# UNITED STATES PATENT AND TRADEMARK OFFICE

APPLICATION NO.	FILING DATE	FIRST NAMED INVENTOR	ATTORNEY DOCKET NO.	CONFIRMATION NO.
10/689,243	10/20/2003	Liuxin Newman	5447-8	3864

## Office Action Summary

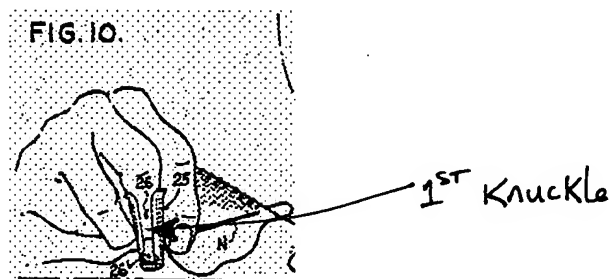
Lambert discloses a substantially rigid thimble (figure 1). The thimble is fabricated from two elongate strips (1, 2) which may be metal or heat treated plastic and is therefore substantially rigid. The thimble extends up and over the first knuckle position of a wearer since the specification states that some rings (20, 30) may be extended in length as in between the knuckle joints (Col. 3, lines 23-25). The outer surface of the thimble is a needle-contacting surface having one or more indents between the tip of the finger and a position adjacent or past the first knuckle position (see figures below).

With regard to claim 4, a multiplicity of indents in the needle-contacting surface is provided between a position adjacent the tip of the finger and a position adjacent the first knuckle.
